Our ref
PLAN-029860

Proposal: Porch to front elevation.

Site: BN/84/19/HH: - 7 Foxes Croft, Barnham, PO22 0JT.

Southern Water MapGuide Browser

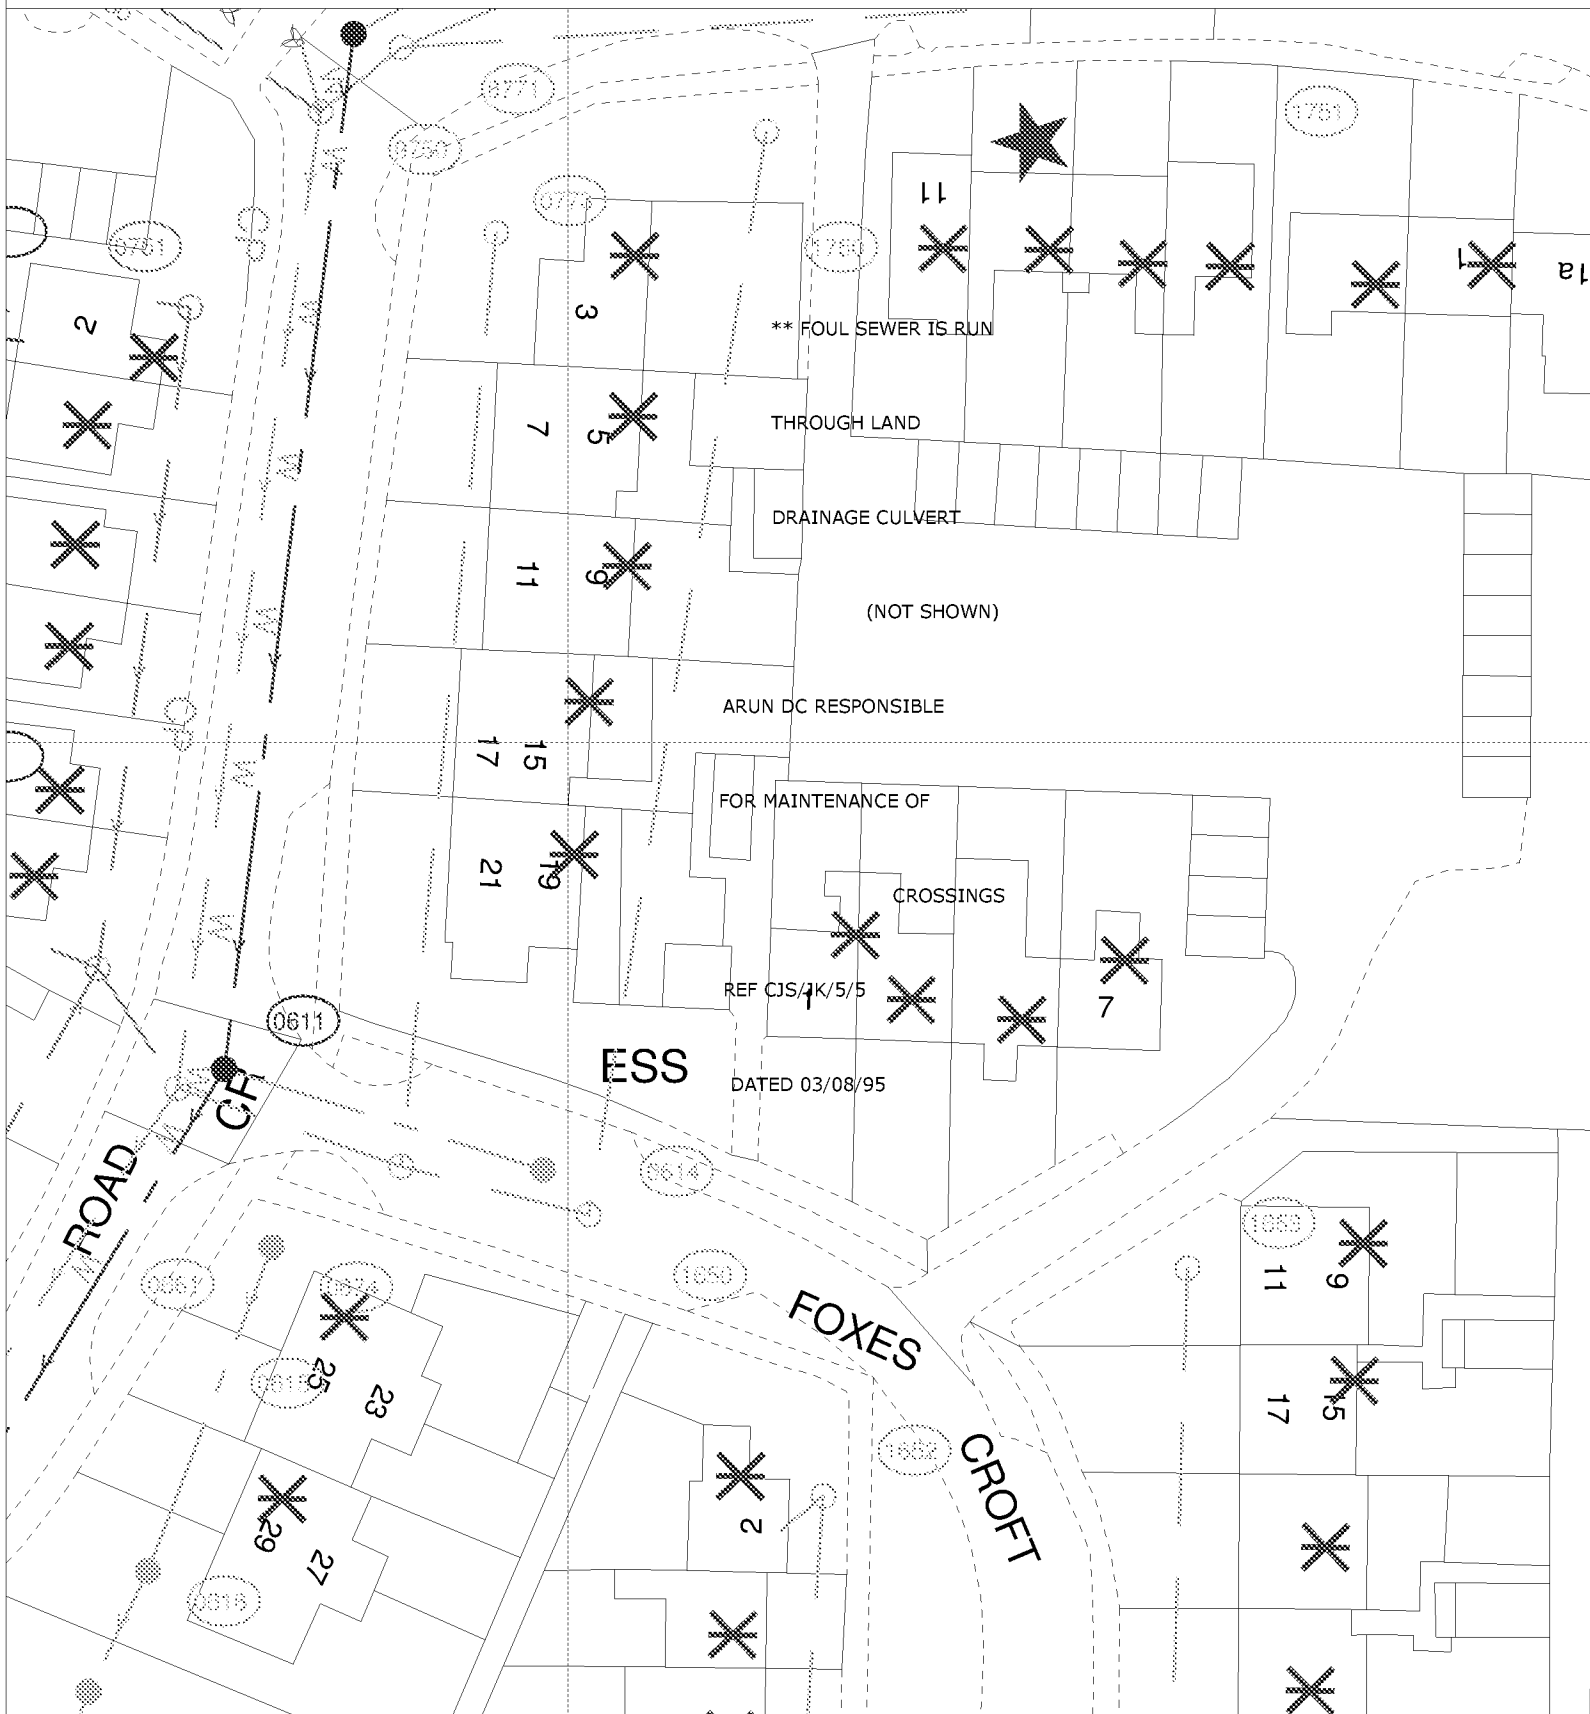
It is possible that a sewer now deemed to be public could be crossing the development site. Therefore, should any sewer be found during construction works, an investigation of the sewer will be required to ascertain its ownership before any further works commence on site.

Due to surface water inundation issues in the Lidsey Catchment the applicant is advised to adopt, where appropriate, the measures in the table "Practical measures to reduce the potential impacts of development". Developer should look to protect the public sewerage system from inundation and infiltration, which contribute to flooding in unfavourable conditions.
